Global Change Notification (GCN)

Product Family	Micro-fit	10664055
		GCN Number
Series	Various	April 13, 2015
		Date Issued
Reason For Change	Manufacturing Process Change	
Change Description	<p>As part of our ongoing efforts to continuously improve Molex products, we are announcing a change in our Micro-Fit, 3.0TM product line. Prior to the implementation of the RoHS initiative resulting in widespread use of lead free solder methods, Molex has used a bright tin over nickel plating on all Micro-Fit, 3.0TM pcb header assemblies. While this plating performs excellently, there have been cases where our customer's solder profiles, combined with the organic brighteners used, resulted in a discoloration of the tin plating, and very rarely, an outgassing of the organic brighteners. While this physical appearance and the outgassing did not affect any of the functional properties of our product, the visual change did cause concern among some customers. Attached are photos showing a "normal" terminal, and one showing the discoloration. Due to the narrow operating window for the organic brighteners, Molex Plating Engineering has determined that it is not feasible to keep the brightener levels

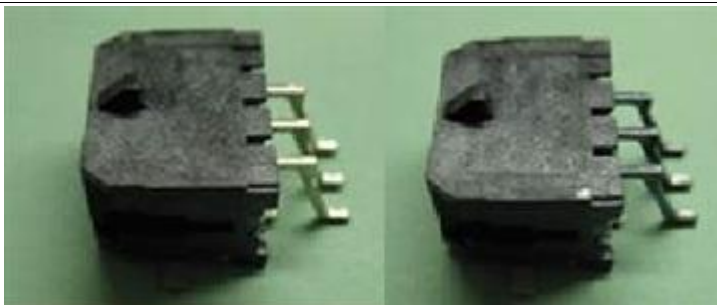
Current plating and discoloration

New reflowed matte tin plating

Part Numbers Affected	Please refer to CustomerPartList.csv attached to e-mail message.
Reason For Short Notice Exception	
Assessment Of Change (How Product Will Be Qualified & Validated)	Molex Engineering has conducted a thorough evaluation and determined that transitioning to reflowed matte tin plating eliminated the above concerns/effects, and provides a high quality finish that Molex customers have come to expect. The attached photos show the appearance of the new reflowed matte tin plating compared to the previous bright tin plating.
Internal Molex Qualification Date (Planned Date Information Available)	March 11, 2015
Sample Availability Date (Changed Part)	March 16, 2015
Date of Implementation	May 06, 2015
Method of Identifying Change	Product made after April 20, 2015 could contain this change
Recommended Replacement Parts	Not Applicable
Last Time Buy Date for Obsolete Parts	
Last Time Ship Date for Obsolete Parts
